From: [Brett Forkner](#)
To: ["Arthur Koepsell - DNR"](#)
Cc: bfinn@ltenv.com
Subject: RE: Nighthawk Production Jolly Ranch 16-19 Sundry Notice 400550843
Date: Friday, February 07, 2014 9:07:21 AM
Attachments: [image001.png](#)

Subject: Nighthawk Production Jolly Ranch 16-19 Sundry Notice 400550843

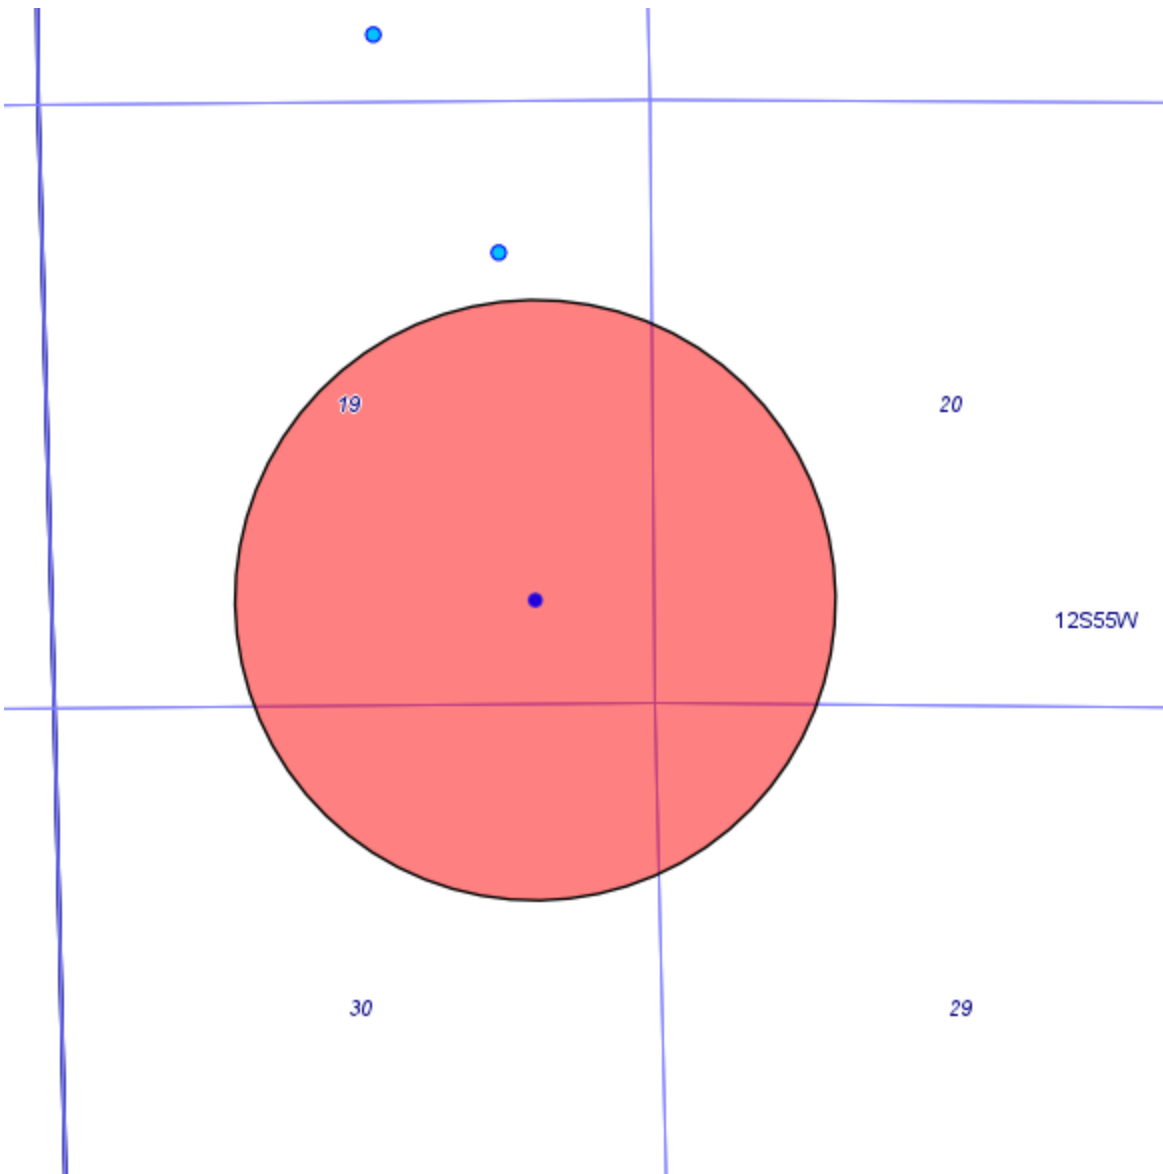
A review of DWR data on the COGCC website indicate that there are no water wells that meet the definition of a water sources within ½ mile of the Jolly Ranch 16-19. The Sundry should be amended to 0 water sources within ½ mil, 4 exceptions under rule 609, 0 Number of water sources determined to be unsuitable. Please agree to the changes by responding to this email.

I have included a map below showing the area surrounding the Jolly Ranch 16-19.

Please change the variance request to reflect your assumptions below. 0 qualifying water wells within ½ mile, 4 exemptions under rule 609, 0 water sources determined to be unsuitable. We did send out an access letter for one unpermitted water well which the landowner did not respond and an access letter for the well just over ½ mile (approximately 3,346 feet away) in which the landowner responded that the water well does not exist.
